REMARKS

This AMENDMENT UNDER 37 CFR 1.111 is filed in reply to the outstanding Office Action of March 14, 2003, and is believed to place this case in condition for allowance for the following reasons.

FIG. 1A PRIOR ART

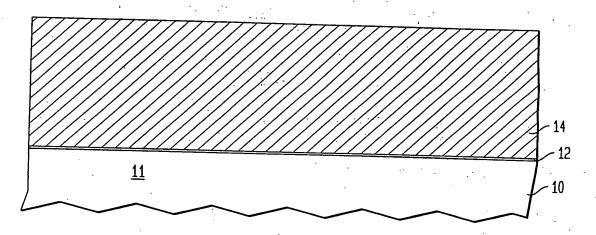
Initially, substitute Figures 1A, 1B, 1C, 1D, 1E and 1F are attached hereto which add the legend PRIOR ART thereto, as proposed in the previous AMENDMENT.
